16-12 Suburban Collection Showplace Expansion

PLANNING REVIEW

Special Land Use and Preliminary Site Plan

Review Date: July 07, 2016
Review Type: Preliminary Site Plan
Project Name: JSP16-12 Suburban Collection Showplace Expansion
Plan Date: 4.18.2016
Prepared by: Sri Ravali Komaragiri, Planner E-mail: skomaragiri@cityofnovi.org
Phone: 248.735.5607

SITE PLAN

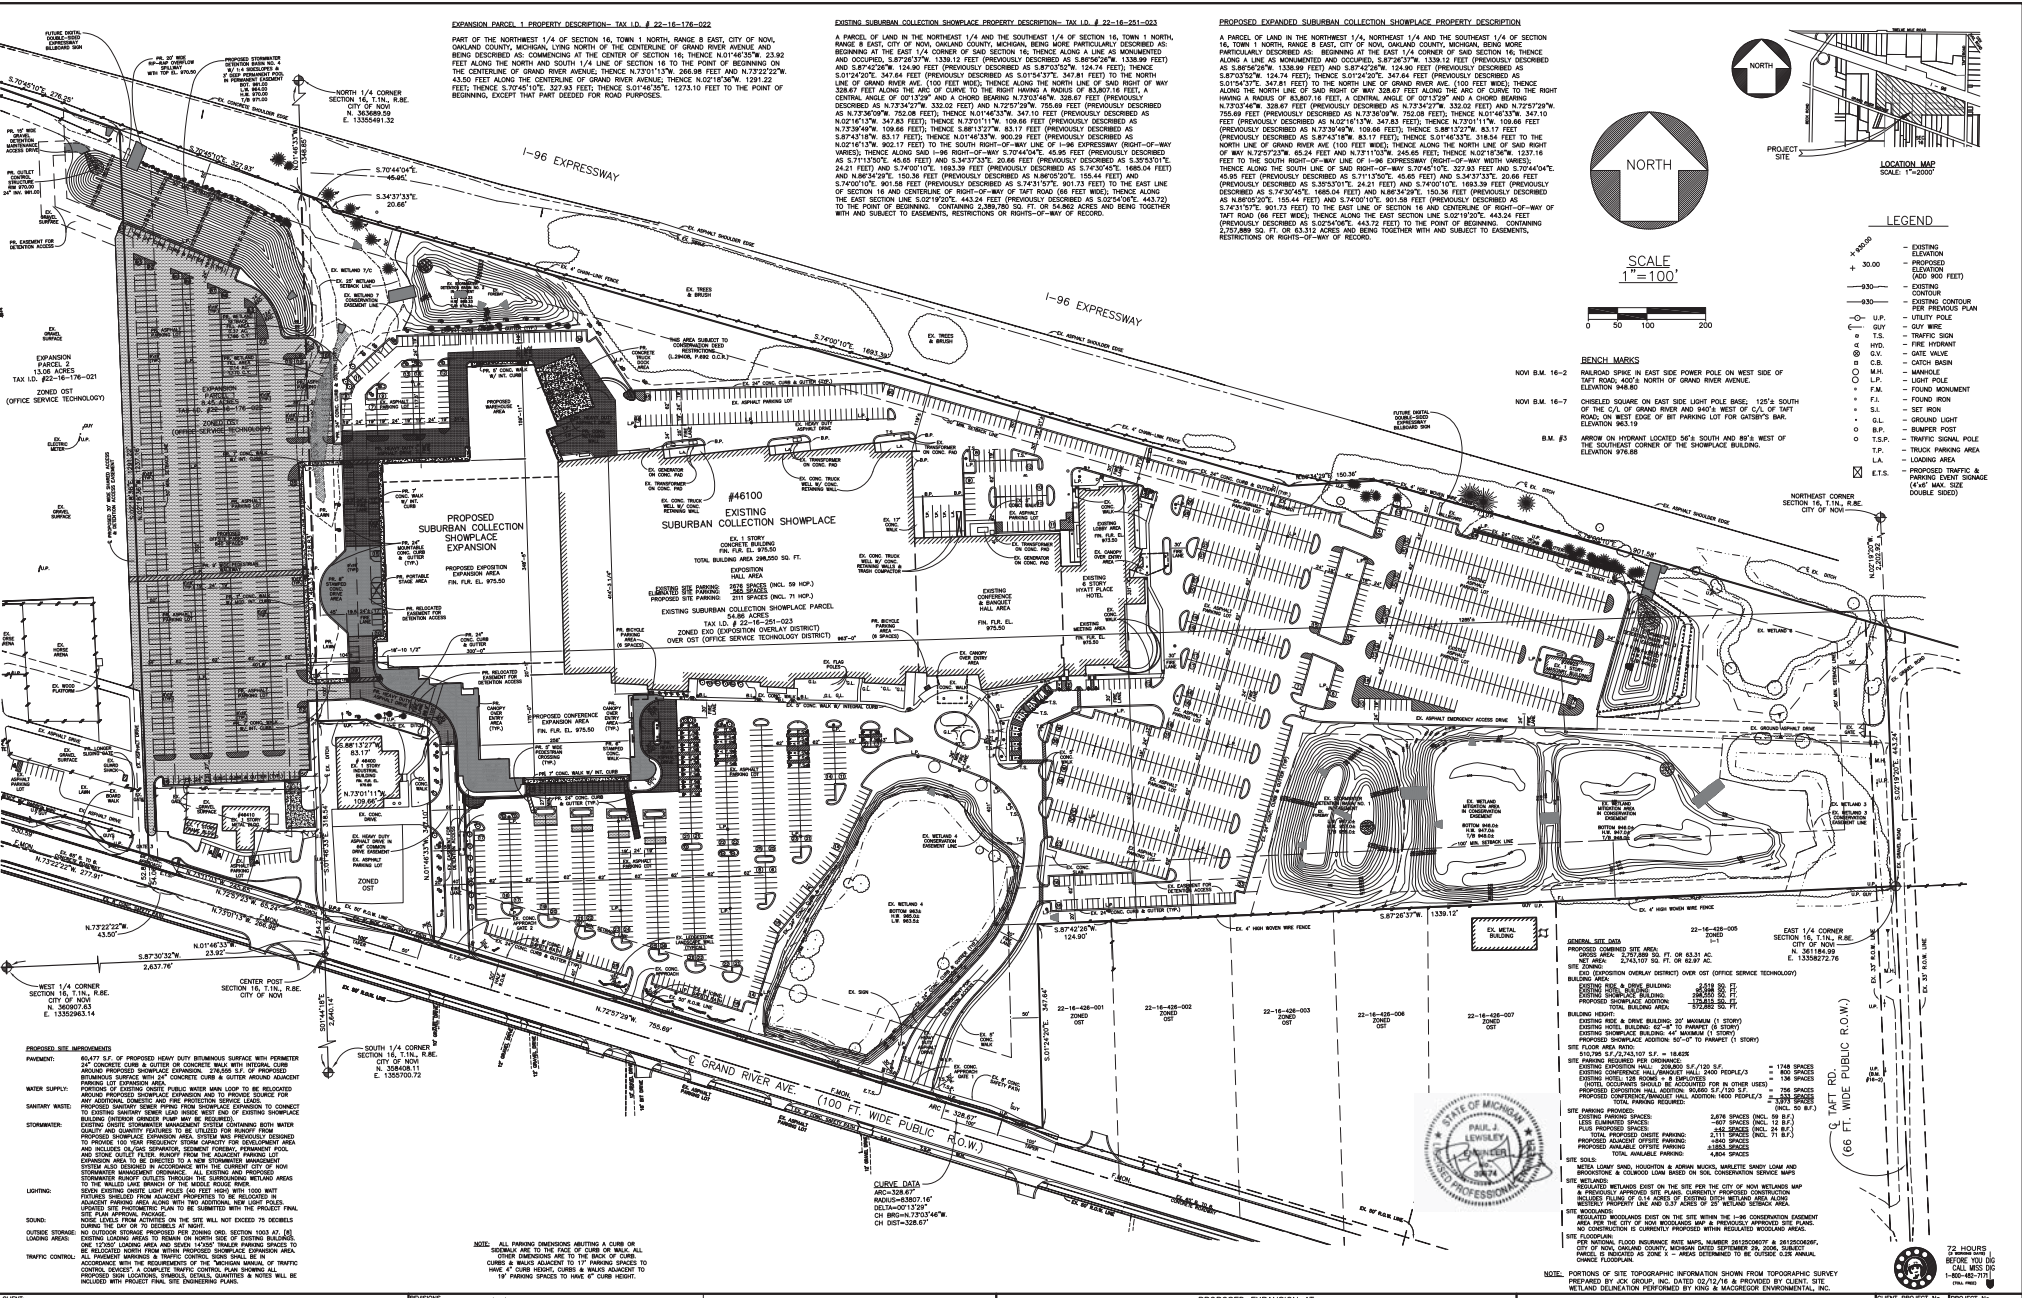
Item	Required Code	Proposed	Meets Code	Comments
<i>Building Code Sec.1106)</i>	thereof, over 1,000 For 2,951 spaces, <u>40 required</u>			sheet C-2 Barrier free spaces shall be distributed among all building entrances according to building code. Provide some handicap accessible spaces near the proposed building entrance on west
Barrier Free Space Dimensions <i>(ICC ANCI a1.17.1 2009)</i>	- 8' wide with an 8' wide access aisle for van accessible spaces - 5' wide with a 5' wide access aisle for regular accessible spaces 12 van spaces required.	19 van spaces proposed	Yes	
Barrier Free Signs <i>(ICC ANCI a1.17.1 2009)</i>	One sign for each accessible parking space.	Barrier free signs are indicated as TSP	Yes	
Minimum number of Bicycle Parking <i>(Sec. 5.16.1)</i>	4 spaces are required per exposition, conference, and hotel use 12 spaces required	Twelve spaces proposed near existing building	Yes	Include the calculations under general site data on sheet C-2

Figure 2. Approximate wetland impact area. Aerial photo source Google Earth (accessed July 11, 2016). Approximate extents of wetland impact is Indicated in yellow.

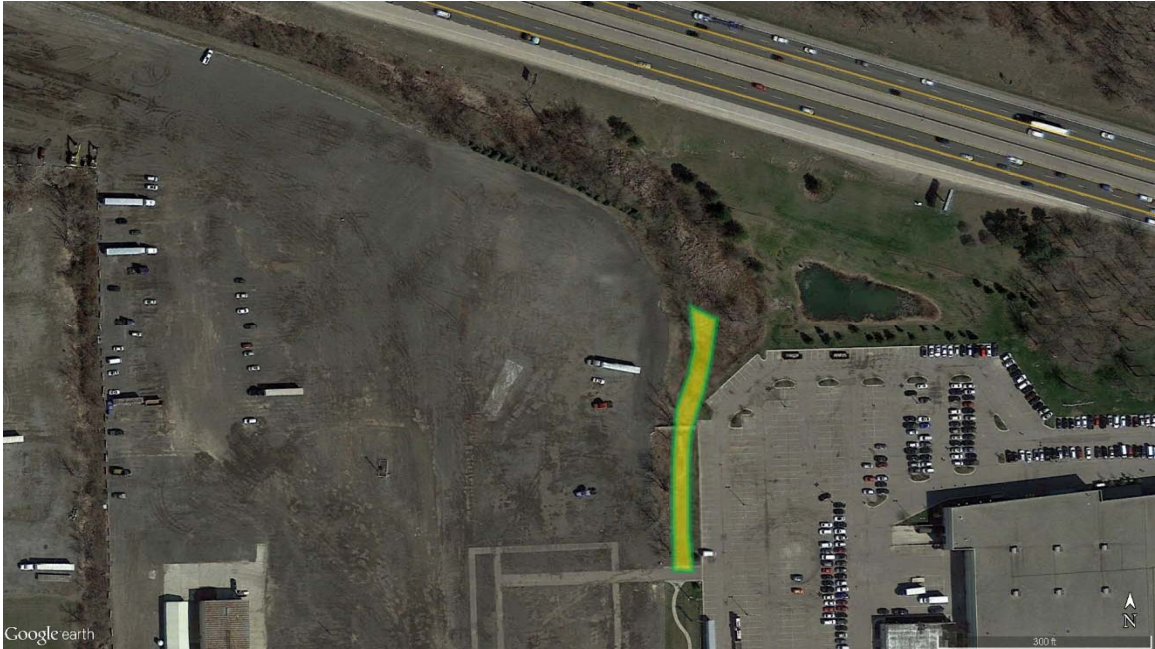
ECT visited the site on April 22, 2015 as well as on July 6, 2016 for the purpose of a wetland boundary verification. The focus of the inspection was to review site conditions in order to determine whether on-site wetland is considered regulated under the City of Novi's Wetland and Watercourse Protection Ordinance. ECT reviewed the wetland area (Wetland 7/C) at the proposed project location. The approximate project boundary is depicted in Figure 1.
